# **AGENDA**

## **DESIGN REVIEW BOARD**

**DESIGN REVIEW BOARD  
for  
TDI - Brooks International Lab  
11-00500142**

**REQUEST:** Waiver to UDO Section 7.9.B.3 "Building Materials" to allow more than 30% wood or cedar siding on the east façade of the laboratory building.

**2 EAST ELEVATION**  
SCALE: 1/8" = 1'-0"

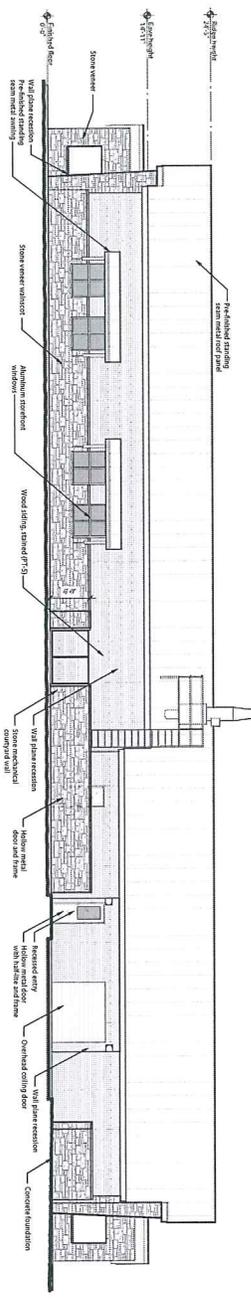
Section 7.9.B.3 “Building Material” limits the use of wood siding to 30% of any façade. The applicant is requesting to utilize wood rainscreen on 49% of the east façade of a laboratory building located within the TDI Brooks International Center private business campus. The proposed wood rainscreen is a tropical hardwood that is intended to be more durable than traditional wood siding. In addition, the product is installed differently from traditional siding methods in a way that allows the wood panels to shed water more efficiently.

*Allow the east façade to have 49% wood rainscreen.*

**RECOMMENDATION:** Staff recommends approval based on the scale of the development, the merit of the proposed material, and the continuation of an architecturally coherent campus.
